1997 - 1998, 2000 Corvette: Service Bulletin: Electronic Steering Column Lock May Refuse to Operate - DIC Service Message Displayed

Number: 01-02-35-008

Subject: Electronic Steering Column Lock May Refuse to Operate - DIC Service Message Displayed (Update Column Lock Wiring, Install Revised Relay and/or Replace Electronic Column Lock)

Model Year: 1997-1998, 2000 Chevrolet Corvette Built Between the Following VIN Breakpoints:

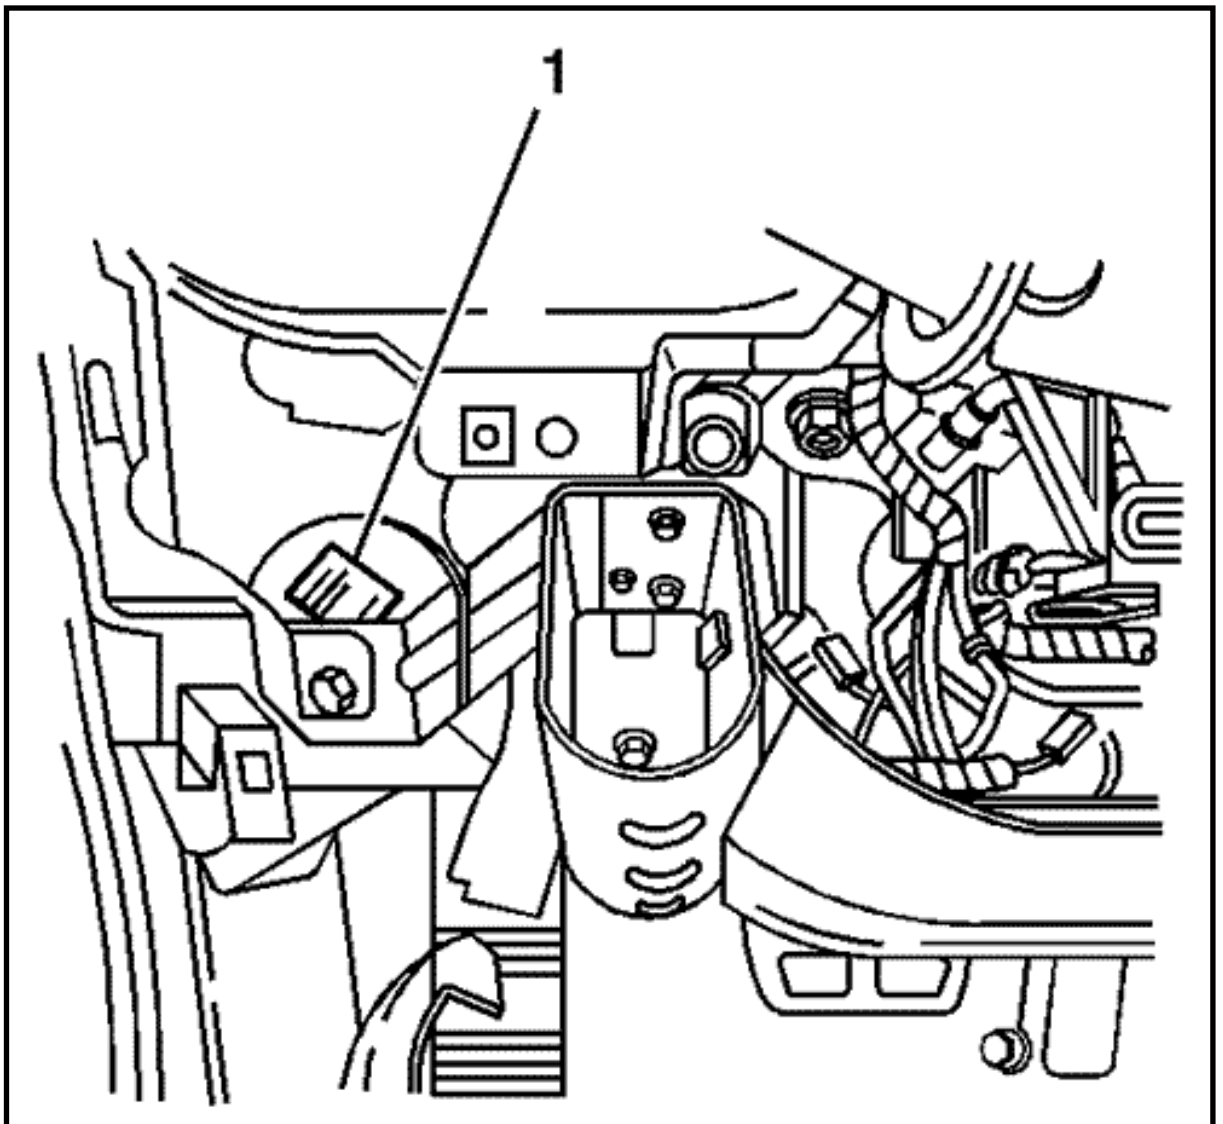
12. Remove and discard the Steering Column Lock/Cam Orientation plate

using the J 38364.

13. Install the included Cam Orientation Plate and secure with a new locking ring, using J 42137 and J 38364 as shown.
14. Install the SIR coil and secure with snap ring.
15. Disconnect the connector from the ECL (located on the right lower side of the steering column) to the I/P main harness.

FIGURE 1997 and 1998 (early) Manual (U.S. & Canada and All Export (Manual & Auto)(c)

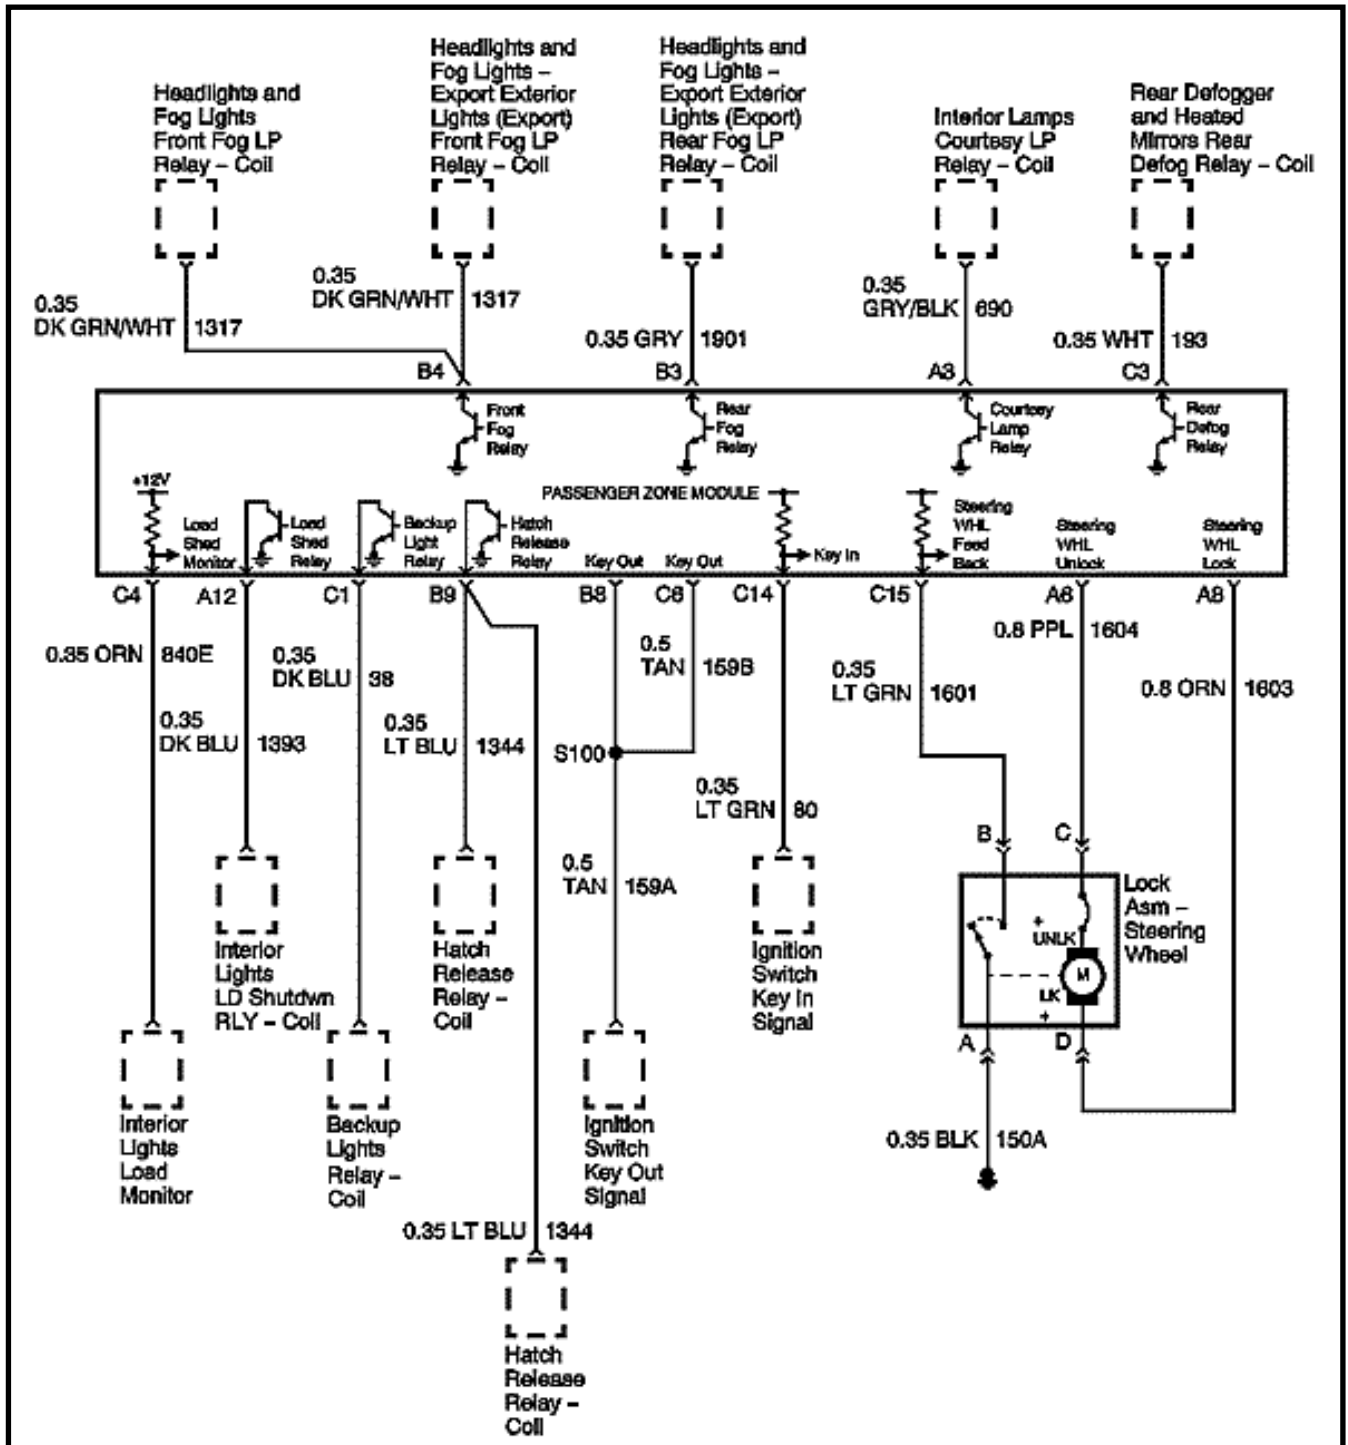
- **In order to complete the wiring upgrades listed in the section, you will need to order P/N 88952428, Wire Kit, Strg Wheel Theft Dtrnt.**
- **You may use the included schematics to aid in verifying the installation of the new relay and jumper wire.**

FIGURE 1997 and 1998 (early) Automatic (U.S. & Canada)(c)

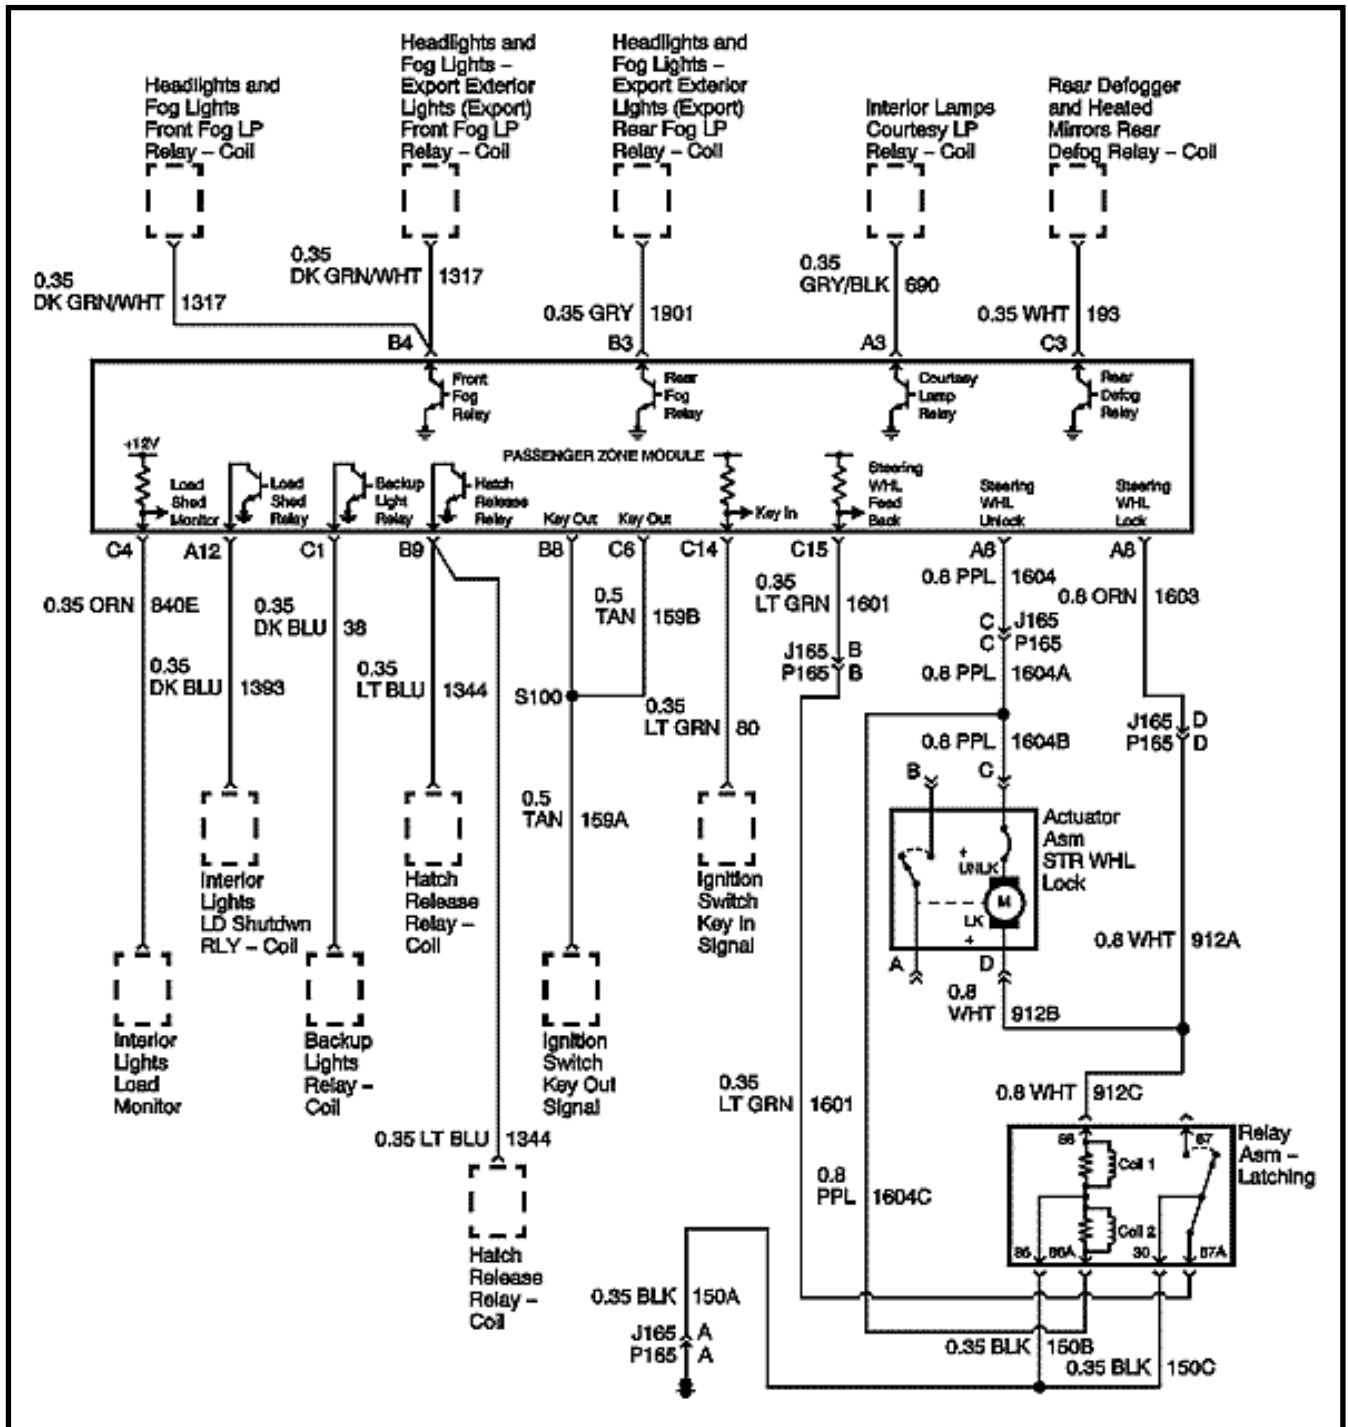
- **When removing the driver's side knee bolster trim panel as described below, care must be taken not to damage the console trim plate as the knee bolster trim panel tucks in behind the console trim plate.**
- **Revised schematics are included to aid and/or verify the proper installation of the service kit.**

FIGURE 2000 (late) Manual and All Export (c)

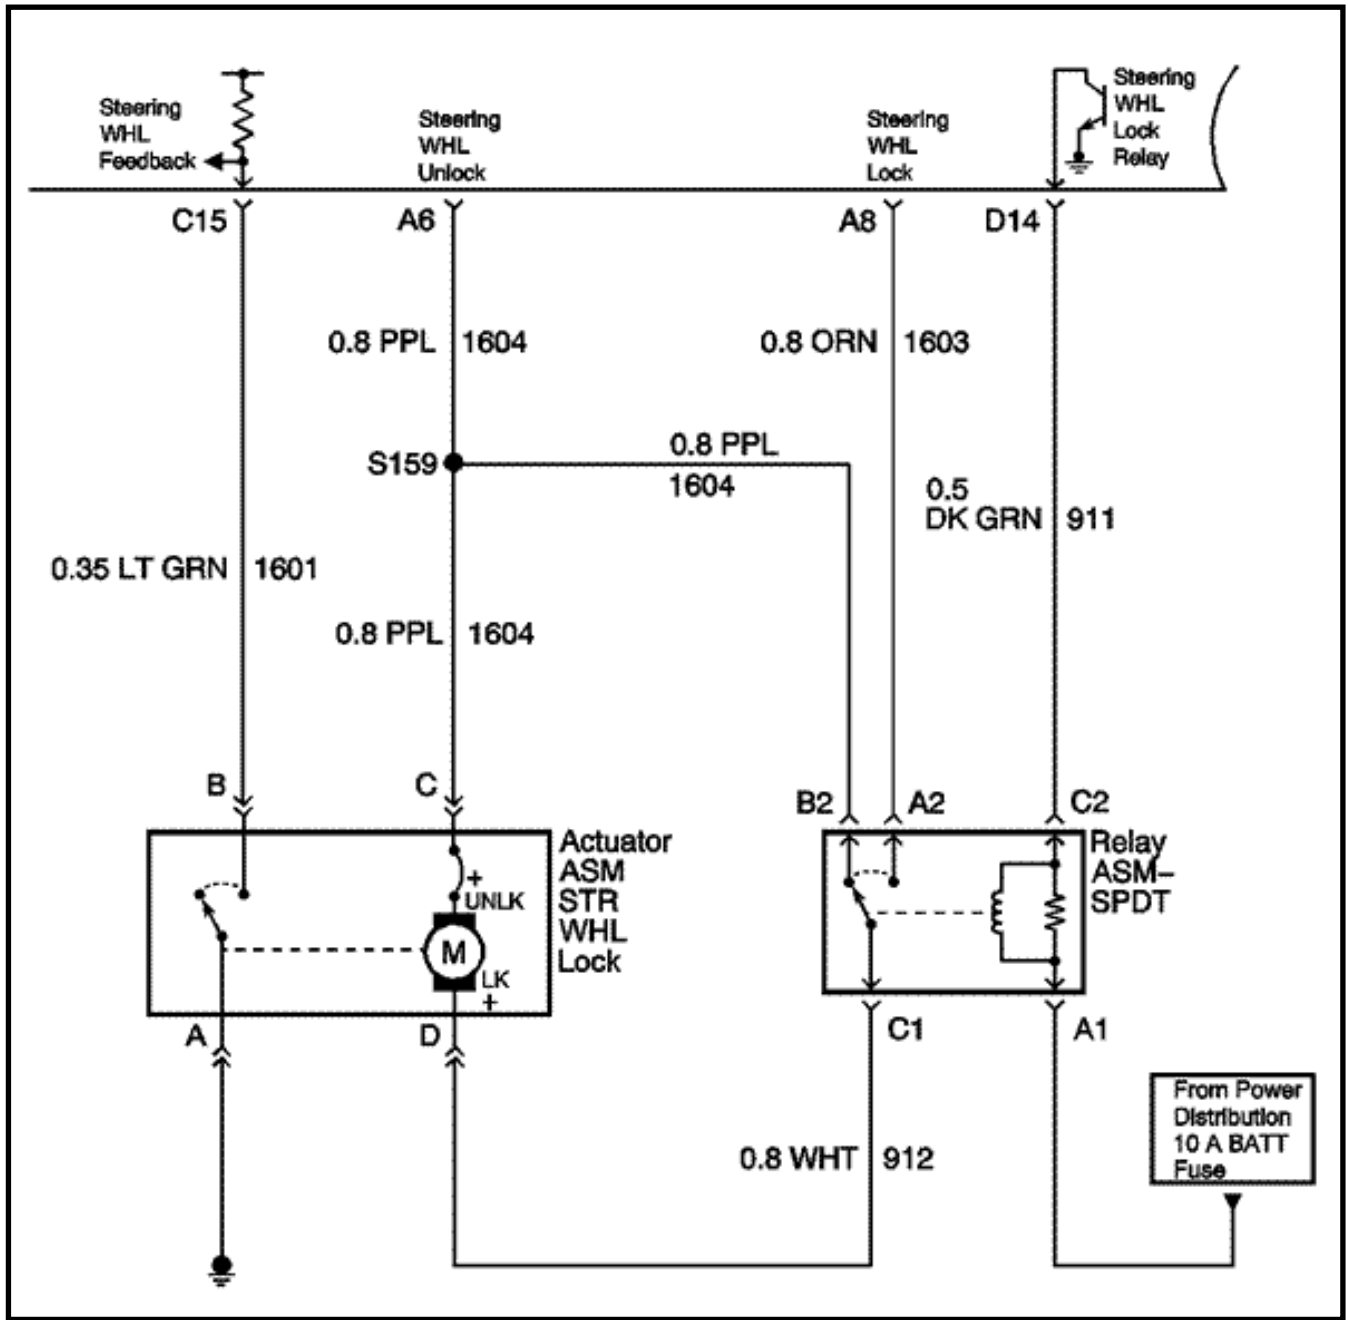
12. Remove the white wire from position A2 on the ECL relay connector.
13. Swap the two terminal positions and re-insert, orange wire to A2 and white wire to C1.

14. Add the new purple wire from the jumper to terminal position B2.
15. Install the new single pole, double throw relay.
16. Install the Green 16-way connector to the BCM.
